Docket No. 50-316

The Commission has issued the enclosed Amendment No. 48 to Facility Operating License No. DPR-74 for the Donald C. Cook Nuclear Plant, Unit No. 2. The amendment consists of changes to the Technical Specifications and imposition of a license condition in response to your application transmitted by letter dated April 7, 1982, as supplemented by letters dated June 11 and June 30, 1982, July 8, 1982, September 30, 1982, December 9 and December 22, 1982 and January 12, 1983.

This amendment approves the Cycle 4 reload, the increase in power level from 3391 to 3411 megawatts thermal, and changes the related Technical Specifications. A License Condition for Cycle 4 is imposed as is a general condition prohibiting Cycle 5 operation until further approval is obtained from the NRC.

DONALD C. COOK NUCLEAR PLANT UNIT NO. 2

FIGURE 3.2-2

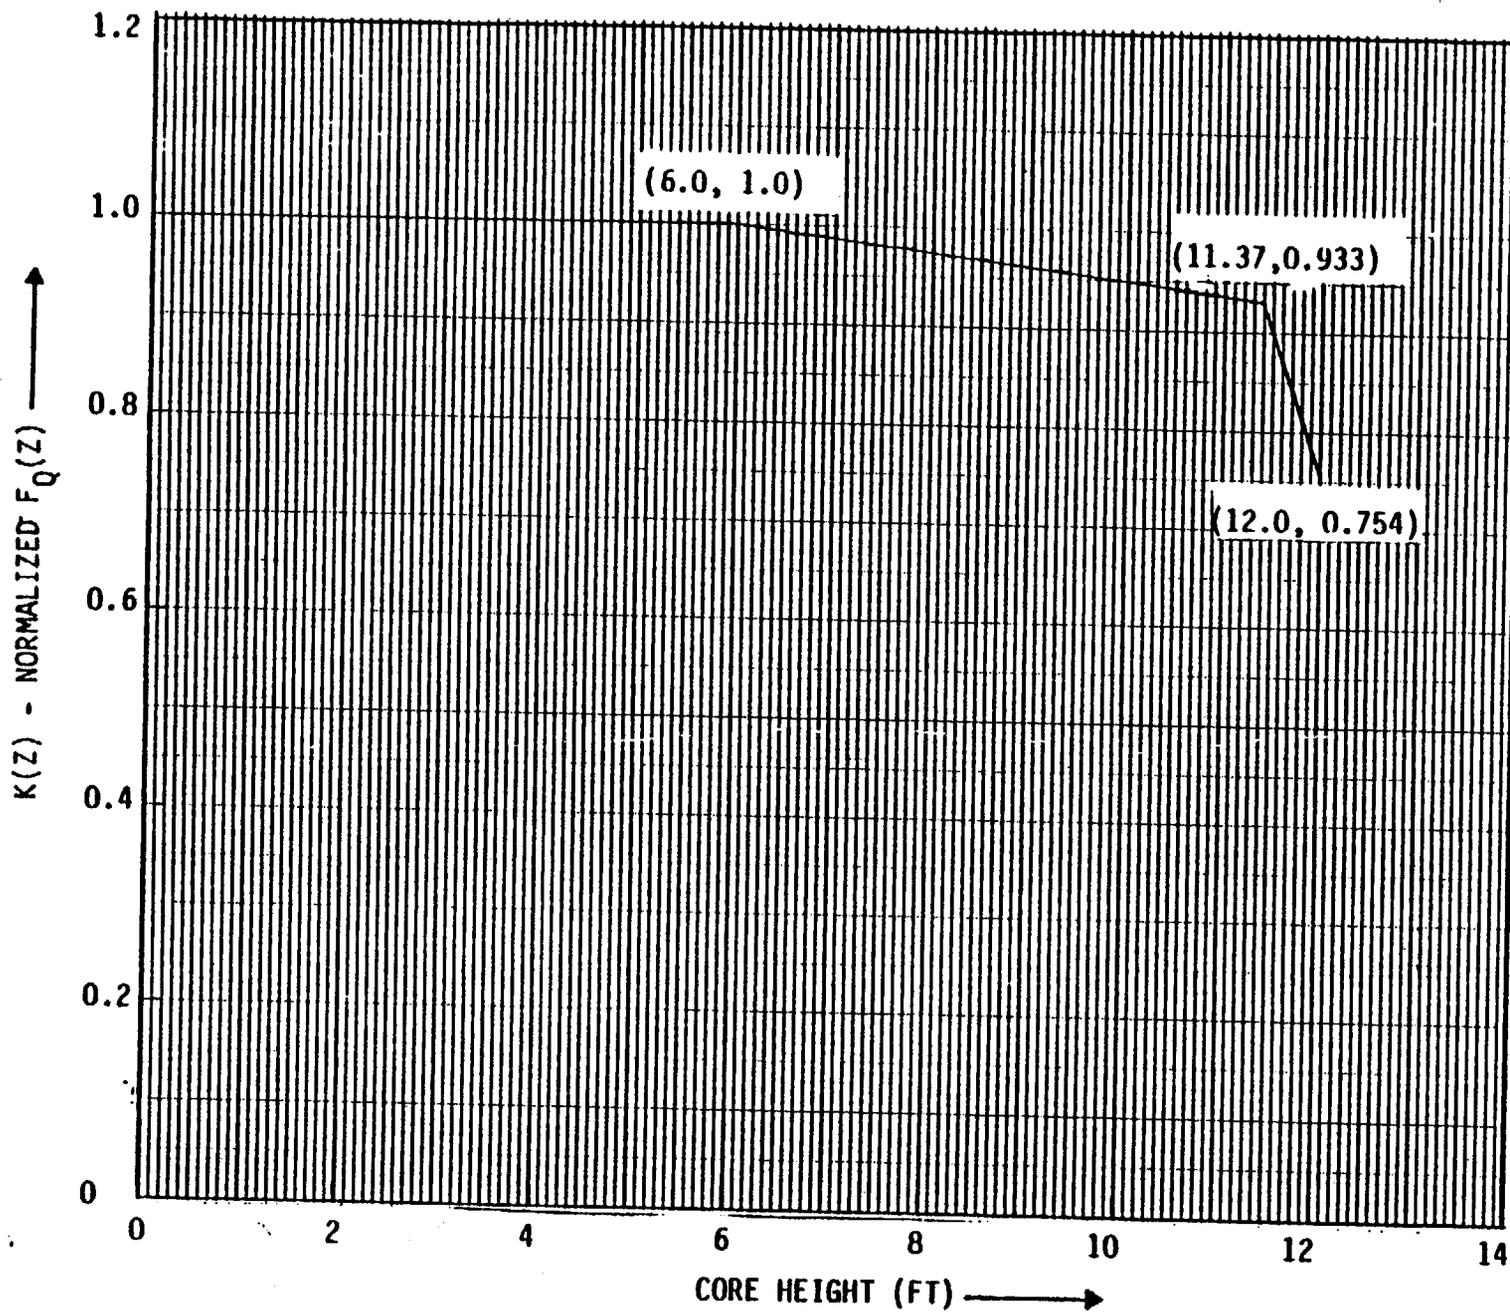
and $K(Z)$ is the function obtained from Figure 3.2-2 for Westinghouse fuel and Figure 3.2-2(a) for Exxon Nuclear Company fuel.

FIGURE 3.2-4 RCS TOTAL FLOWRATE VERSUS R - FOUR LOOPS IN OPERATION

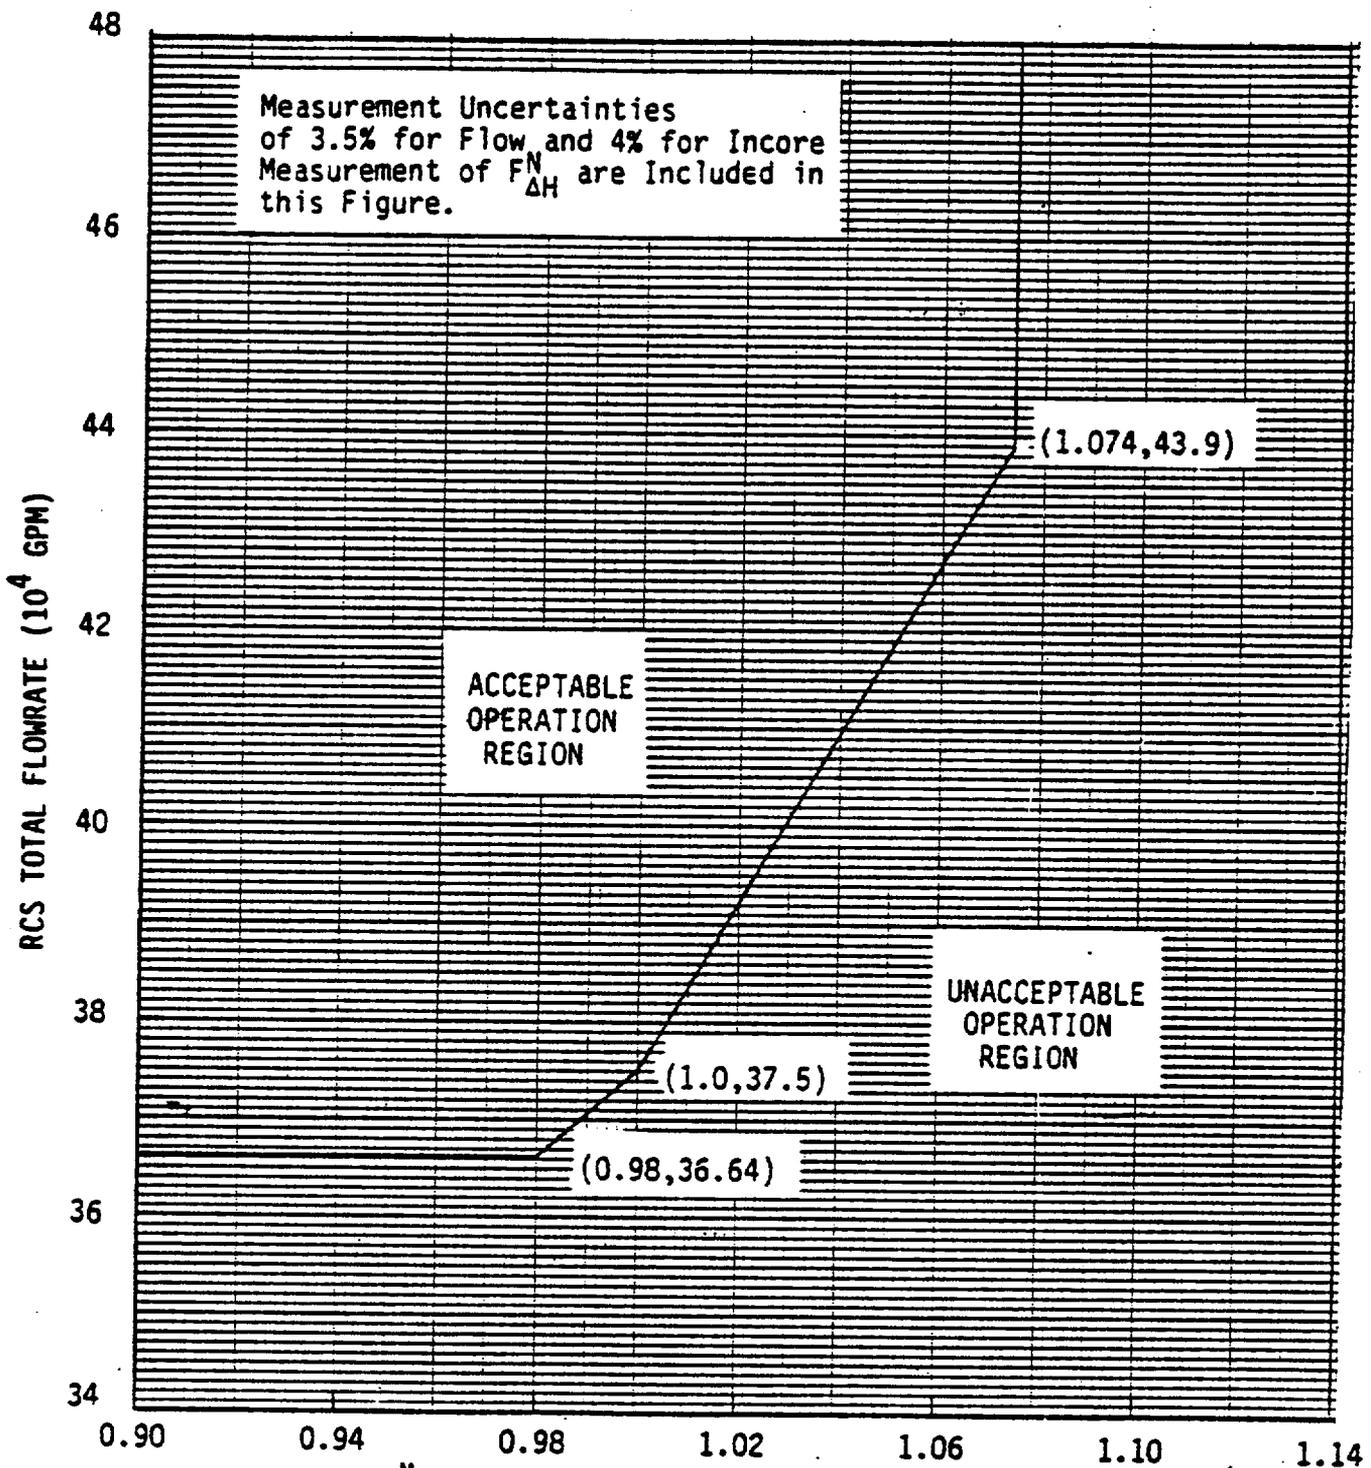
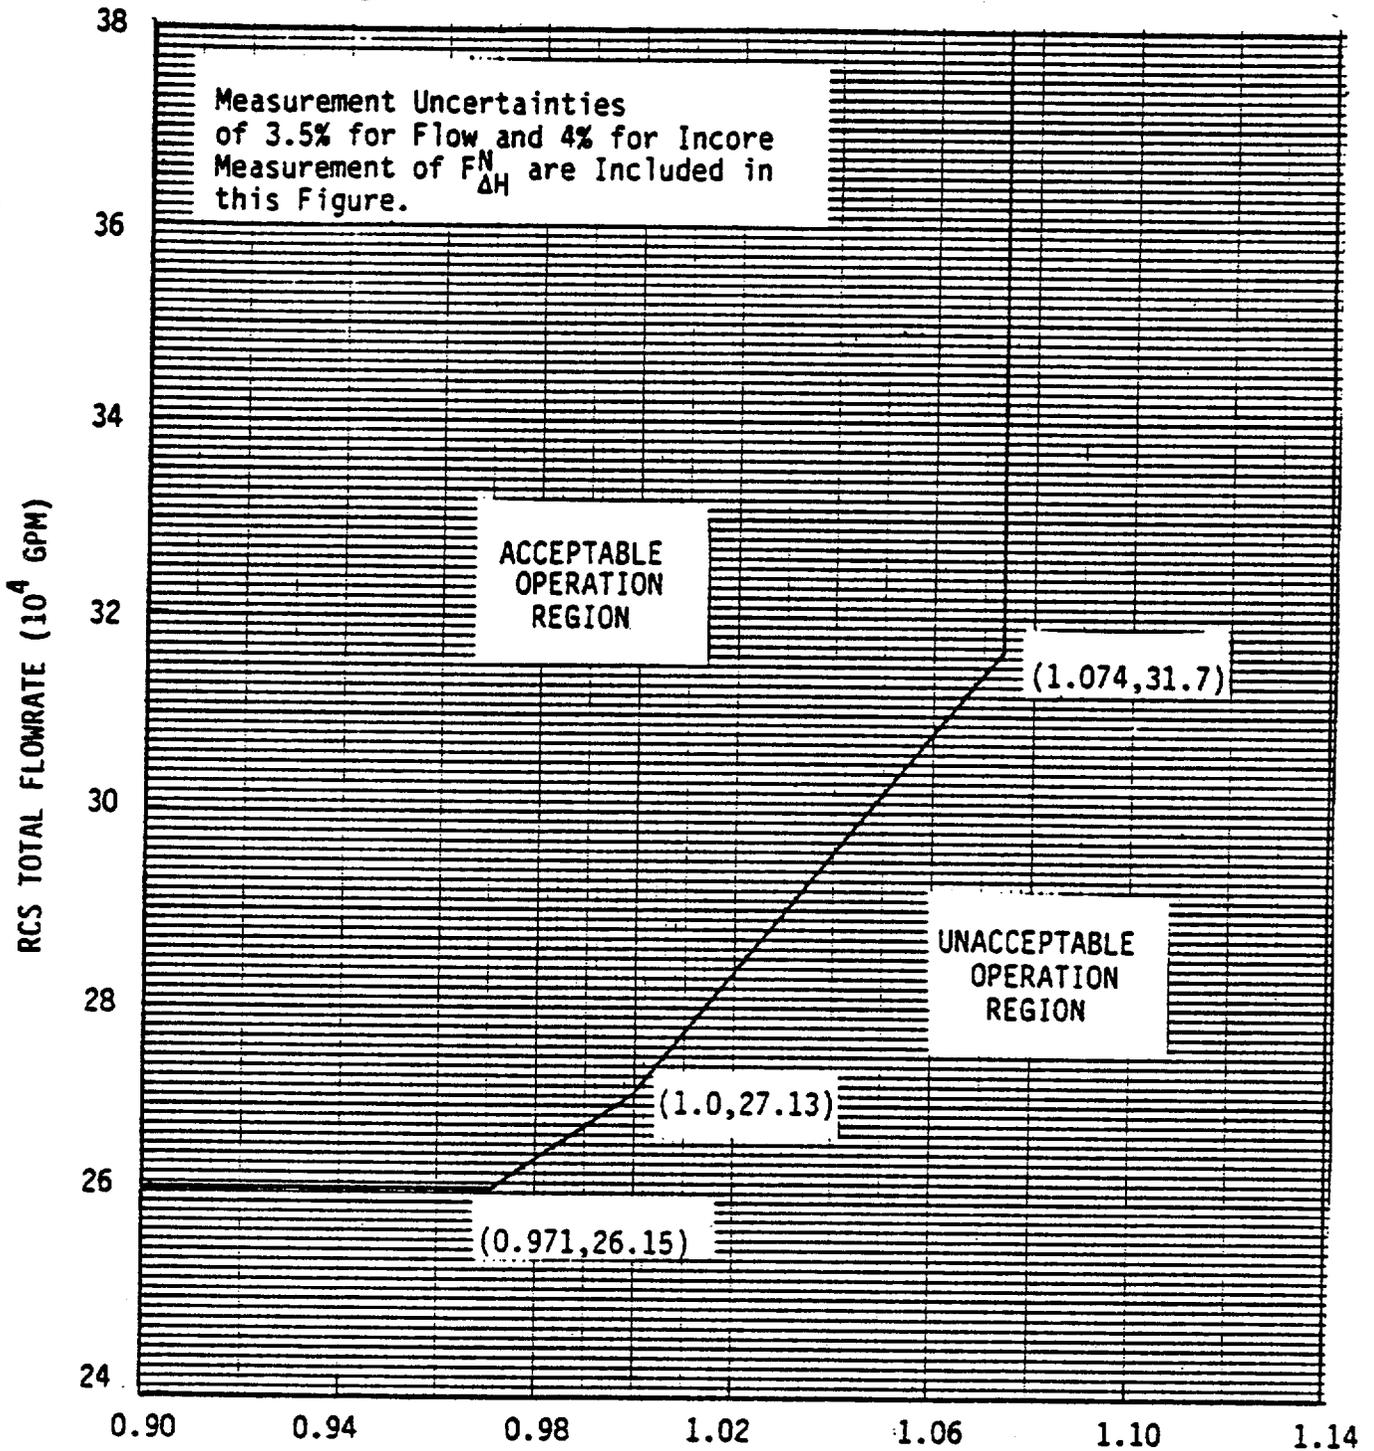
With the combination of RCS total flow rate and R outside the region of acceptable operation shown on Figure 3.2-4 or 3.2-5 (as applicable):

$$R = F_{\Delta H}^N / 1.49 [1.0 + 0.2(1.0 - P)] \text{ EXXON NUCLEAR CO. FUEL}$$
